PRODUCT / PROCESS CHANGE NOTIFICATION

PCN-000780

Qualification of Greatek Taiwan as a second source Assembly manufacturer for LORA and ISM products

SEMTECH Package Outline on SX1231IMLTRT/ SX1232IMLTRT/ SX1233IMLTRT/ SX1239IMLTRT (Carsem and Greatek)

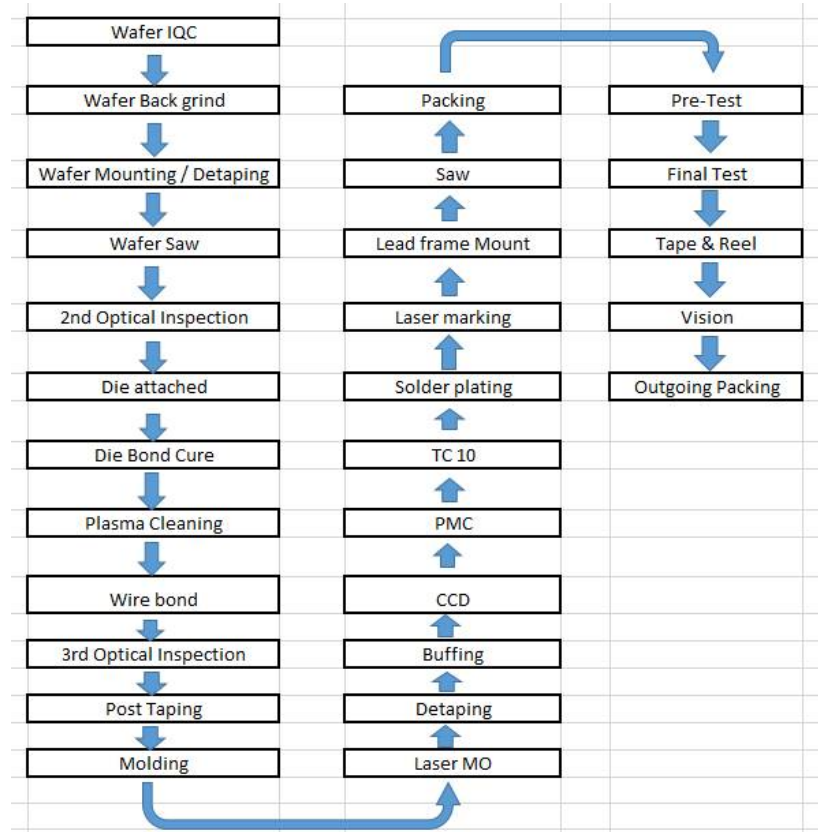
**No Change in
Package Outline.**

Wire Bonding sequence SX1232IMLTRT (Carsem vs Greatek)

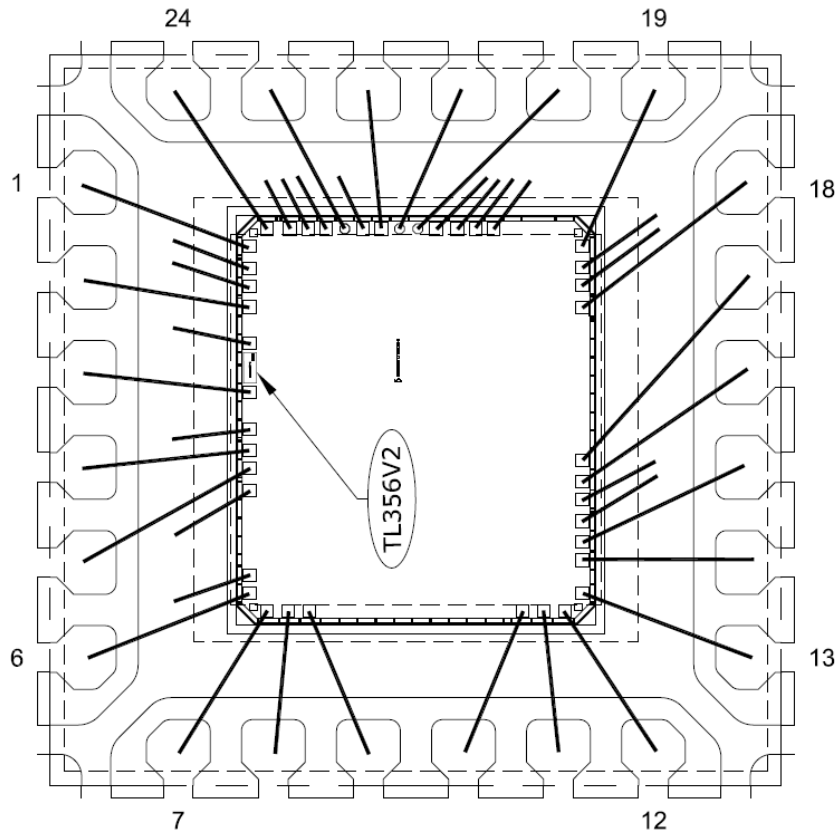
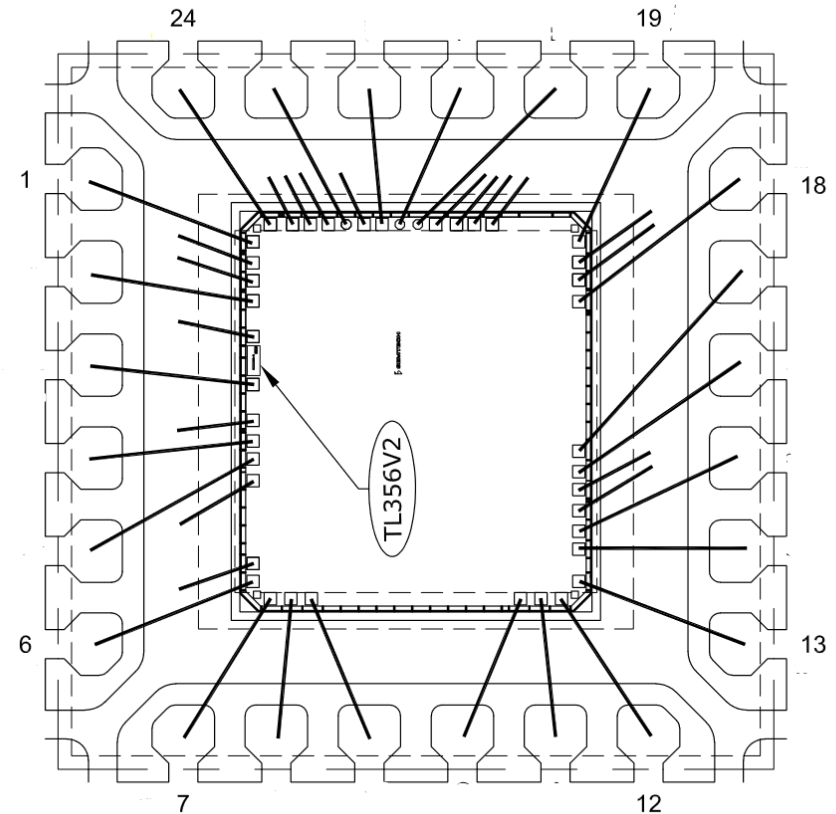
- Both supplier – Carsem and Greatek are bonding the down bond wires as 1st priority although there is some difference on its down bond sequence.
- Followed by those I/O pad wires. Although bonding on I/O pad wires were also having some differences. This would not impacted its electrical performance.

Wire Bonding sequence SX1231IMLTRT, SX1233IMLTRT, SX1239IMLTRT (Carsem vs Greatek)

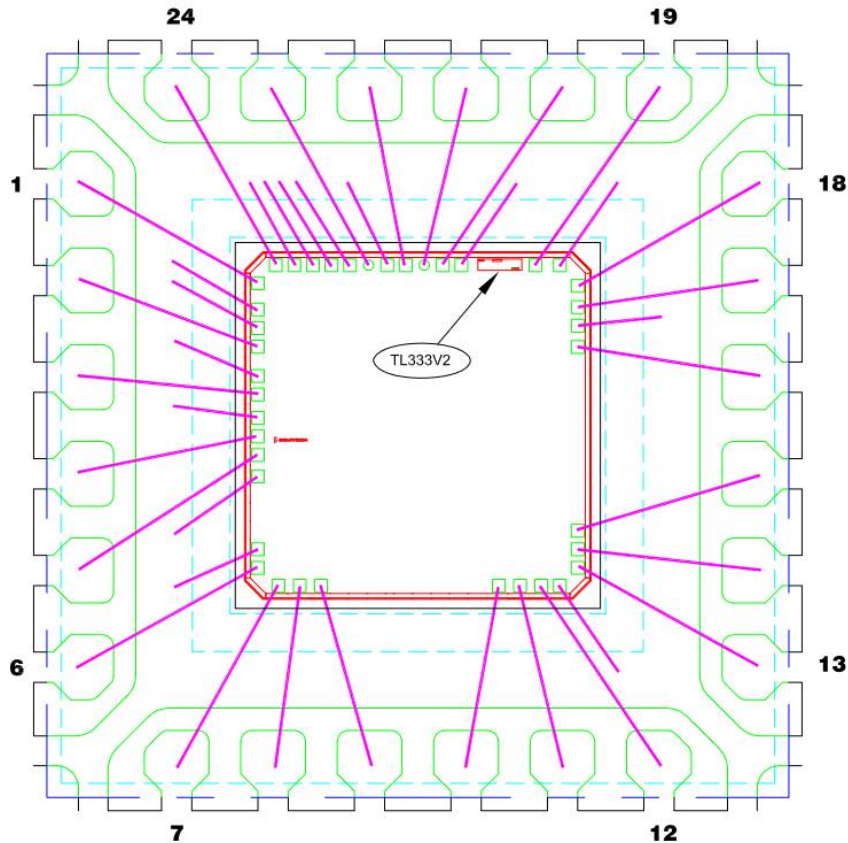
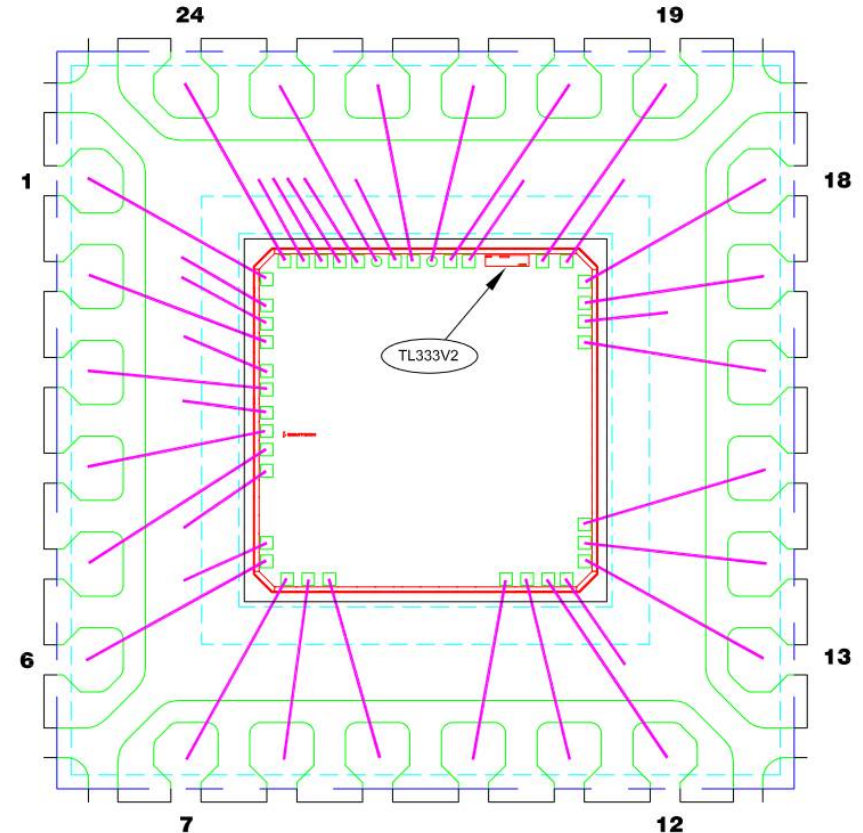
- Both supplier – Carsem and Greatek are bonding the down bond wires as 1st priority. – Same sequence.
- Followed by those I/O pad wires. Although bonding on I/O pad wires were having some differences. This would not impacted its electrical performance.

Carrier tape 5x5 comparison (Carsem Vs Greatek)

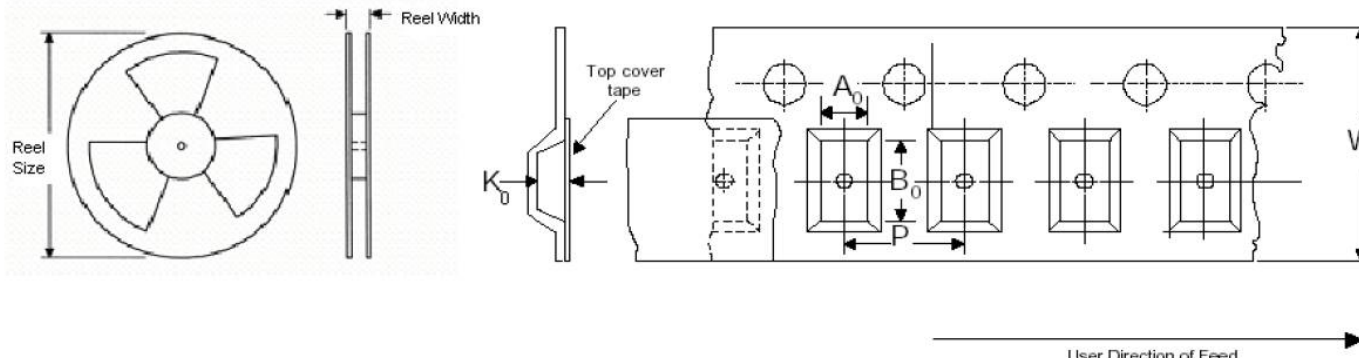
Although carrier tape supplier were different but critical dimension were no difference.
